Design Review Board – Neighborhood Panel

Agenda Workshop

**Planning Staff Report to
Design Review Board - Neighborhood
May 24, 2022**
for the June 2, 2022 Public Hearing

**Planning Staff Report to
Design Review Board - Neighborhood
May 17, 2022**
for the June 2, 2022 Public Hearing

Existing Right Elevation w/ Demo
1/4" = 1'-0"

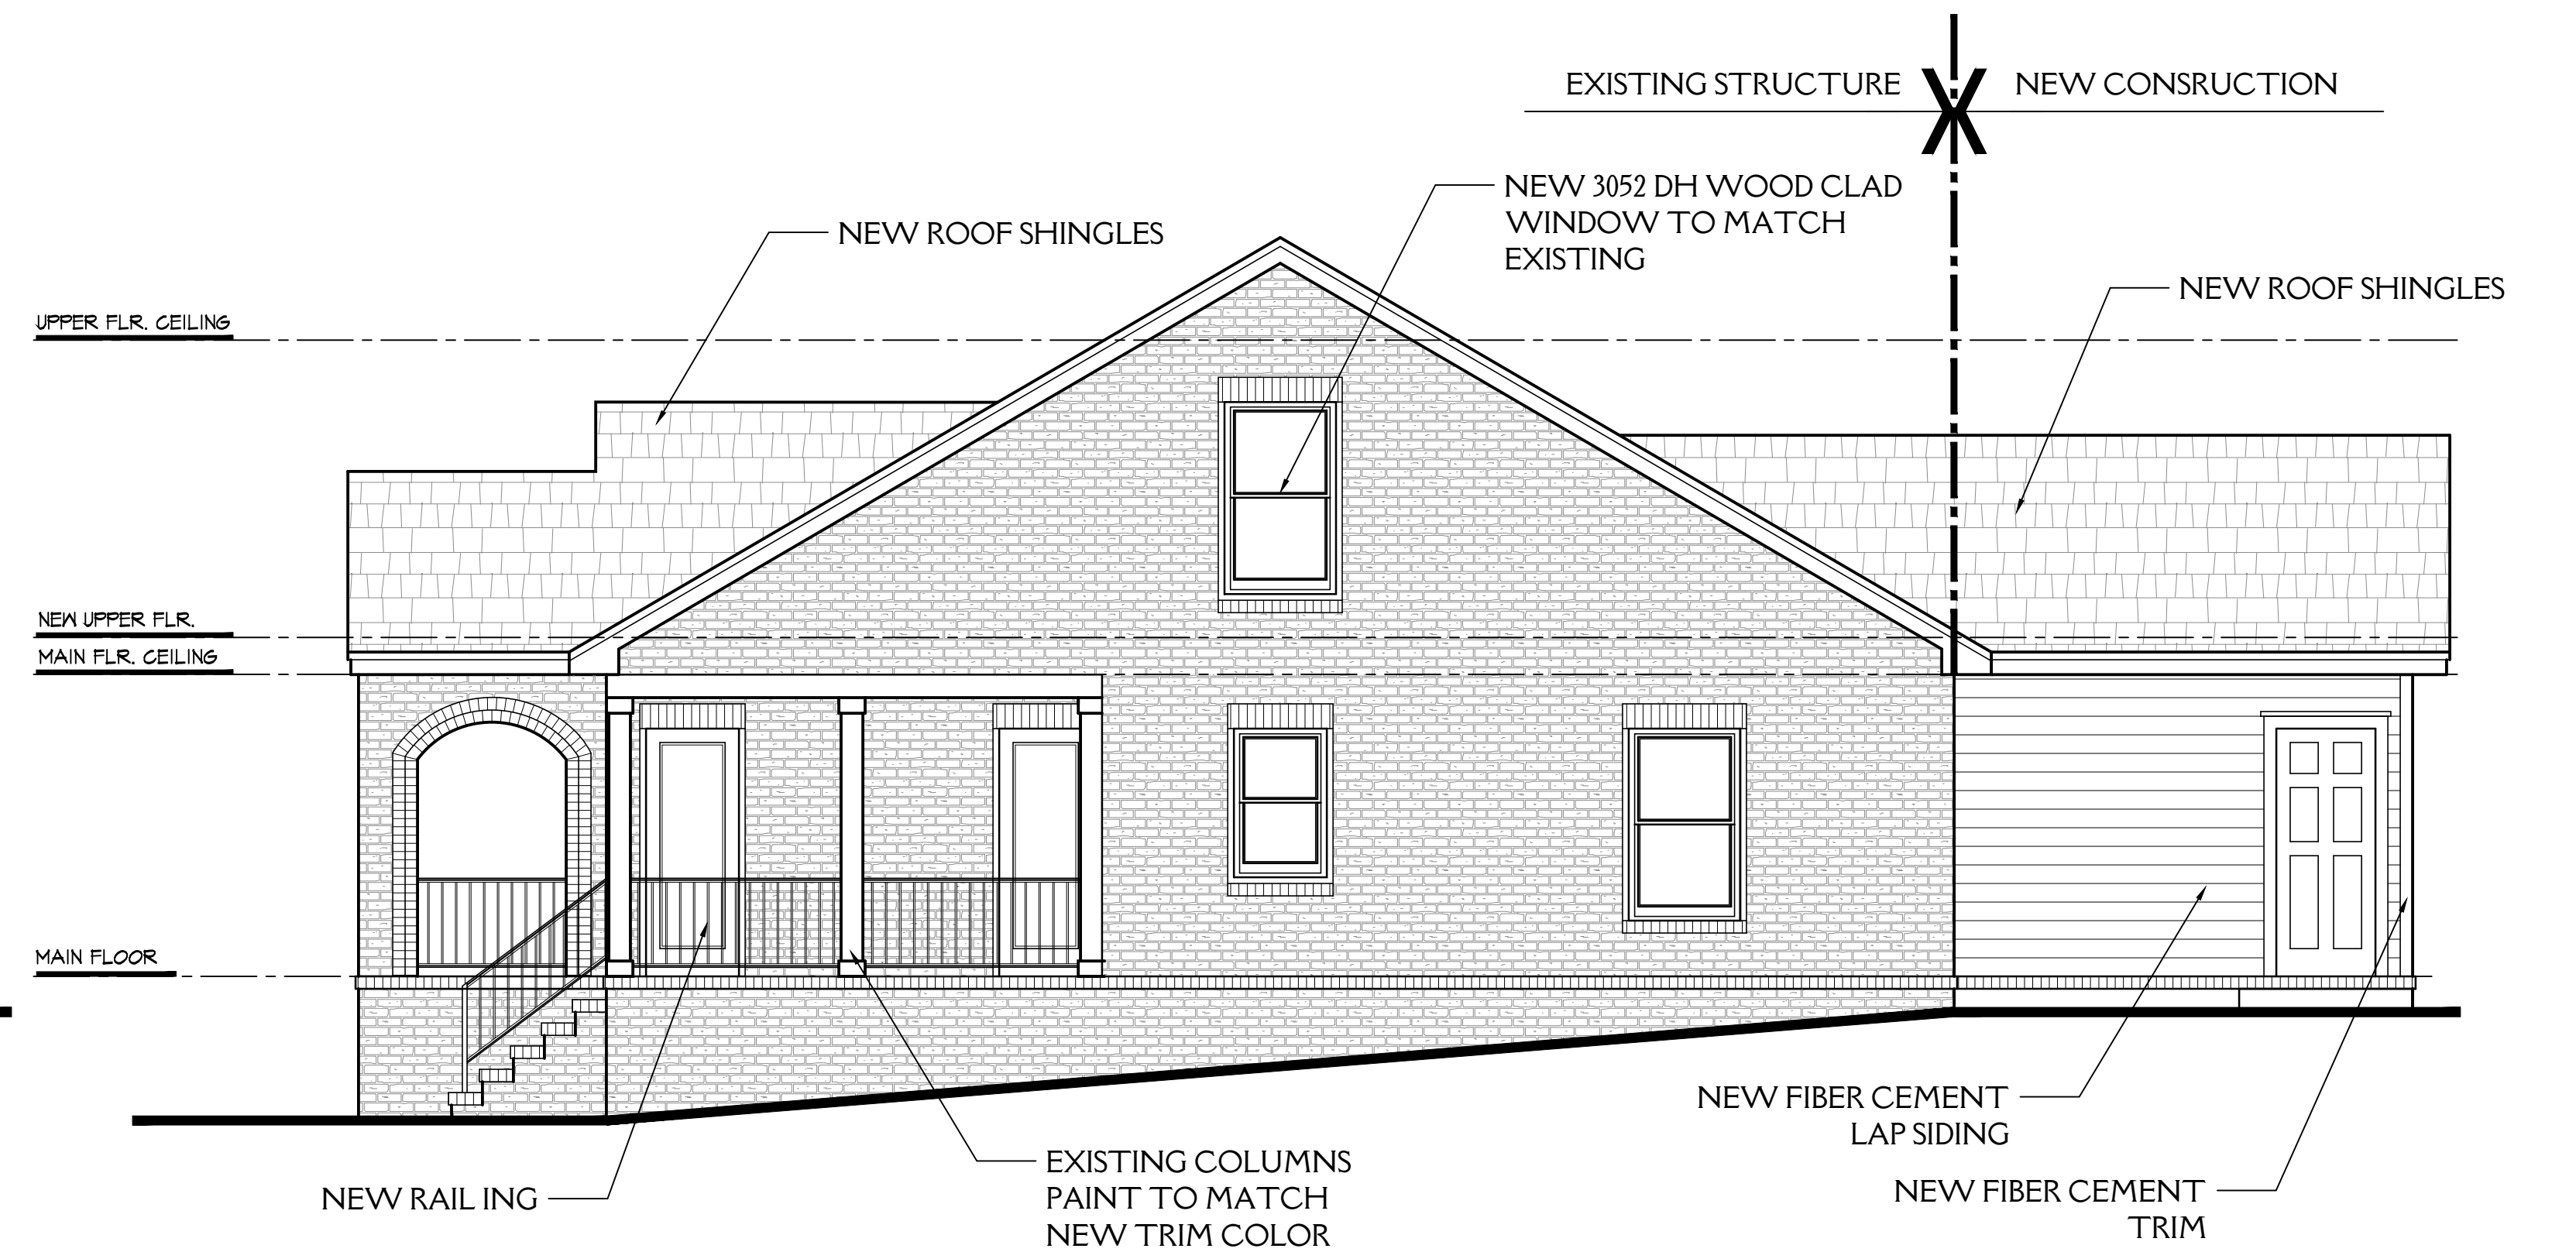
The proposed materials of Hardie Plank are suitable for the new rear addition, but the historic brick should be maintained and preserved on the remainder of the house and not painted as is proposed. HR.9 Masonry Construction, recommends that brick that was not painted historically should not be painted.

Staff finds that removal of the chimneys is not compatible with the design guidelines outlined in Chapter 9. Overbrook Historic District. The introduction specifically calls out chimneys as contributing to the historic district and should be maintained. While Design Guidelines do not dictate interior modifications and would therefore allow for the proposed removal of the fireplaces the existing historic chimneys should be preserved. Structural engineering efforts should be made to maintain the existing elevation of the house.
